Access Compliance Report

Public Rights-of-Way

(Curb Ramps)

Intersection ID: 43649	Main Street: FERGUSON_FOREST_DR	Cross Street: SWANN_BRANCH_DR	Location: SE
ADA ID: 991A4F40119E	Ramp Type: Perp	Initial Pass/Fail: Fail	Overall Compliance: No
Codes/Mitigation Info/Possible Solution		Field Measurements/Component Compliance	
Severity Score: 8.75

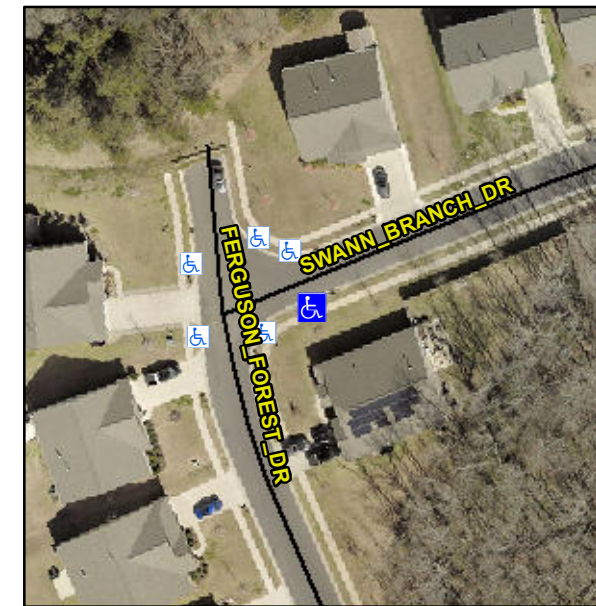
Not Found, R304.5.1

Compliance	Description	Data	Compliance	Description	Data
N/A	Ramp Length (in)	47.0	Yes	Ramp Slope (%)	6.7
No	Ramp Width (in)	47.0	Yes	Ramp XSlope (%)	0.5
N/A	Flare Type LT	N/A	N/A	Flare Type RT	N/A
N/A	Flare Slope LT (%)	N/A	N/A	Flare Slope RT (%)	N/A
N/A	Flare Traversable LT?	N/A	N/A	Flare Traversable RT?	N/A
N/A	Landing Length (in)	N/A	N/A	DWS Provided?	N/A
N/A	Landing Width (in)	N/A	N/A	DWS Contrast?	N/A
N/A	Landing Slope (%)	N/A	N/A	DWS Length (in)	N/A
N/A	Landing X Slope (%)	N/A	N/A	DWS Full Width?	N/A
N/A	Landing Curb? (Y/N)	N/A	N/A	DWS Offset (in)	N/A
N/A	Shared Landing?	N/A			
N/A	Gutter Ponding?	N/A	N/A	Gutter Slope (%)	N/A
N/A	Gutter Lip Ht (in)	N/A	N/A	Gutter X Slope (%)	N/A
N/A	Painted X Walk1?	No	N/A	Painted X Walk2?	N/A
	X Walk 1 Direction	To N		X Walk 2 Direction	N/A
N/A	X Walk 1 Width (in)	N/A	N/A	X Walk 2 Width (in)	N/A
	X Walk 1 Slope (%)	2.0		X Walk 2 Slope (%)	N/A
	X Walk 1 X Slope (%)	0.1		X Walk 2 X Slope (%)	N/A

Remove & Replace Entire Ramp.
